Access Compliance Report

Public Rights-of-Way

(Curb Ramps)

Intersection ID: 2889	Main Street: ALLNESS_GLEN_LN	Cross Street: HARBURN_FOREST_DR	Location: W
ADA ID: 5F05F5D30CEC	Ramp Type: PerpDiag	Initial Pass/Fail: Fail	Overall Compliance: No
Severity Score: 58.75			
Codes/Mitigation Info/Possible Solution		Field Measurements/Component Compliance

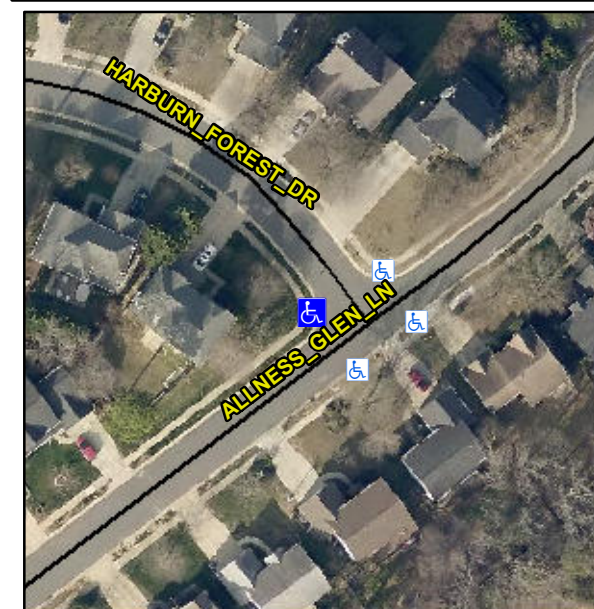
Not Found, R304.5.1, R304.2.2, R304.5.3

Compliance	Description	Data	Compliance	Description	Data
N/A	Ramp Length (in)	48.0	No	Ramp Slope (%)	15.0
No	Ramp Width (in)	47.5	No	Ramp XSlope (%)	8.0
N/A	Flare Type LT	N/A	N/A	Flare Type RT	N/A
N/A	Flare Slope LT (%)	N/A	N/A	Flare Slope RT (%)	N/A
N/A	Flare Traversable LT?	N/A	N/A	Flare Traversable RT?	N/A
N/A	Landing Length (in)	N/A	N/A	DWS Provided?	N/A
N/A	Landing Width (in)	N/A	N/A	DWS Contrast?	N/A
N/A	Landing Slope (%)	N/A	N/A	DWS Length (in)	N/A
N/A	Landing X Slope (%)	N/A	N/A	DWS Full Width?	N/A
N/A	Landing Curb? (Y/N)	N/A	N/A	DWS Offset (in)	N/A
N/A	Shared Landing?	N/A			
N/A	Gutter Ponding?	N/A	N/A	Gutter Slope (%)	N/A
N/A	Gutter Lip Ht (in)	N/A	N/A	Gutter X Slope (%)	N/A
N/A	Painted X Walk1?	No	N/A	Painted X Walk2?	No
	X Walk 1 Direction	To SE		X Walk 2 Direction	To NE
N/A	X Walk 1 Width (in)	N/A	N/A	X Walk 2 Width (in)	N/A
	X Walk 1 Slope (%)	11.9		X Walk 2 Slope (%)	0.1
	X Walk 1 X Slope (%)	5.0		X Walk 2 X Slope (%)	6.4

Remove & Replace Curb Ramp With Two New Directional Ramps or Equivalent.
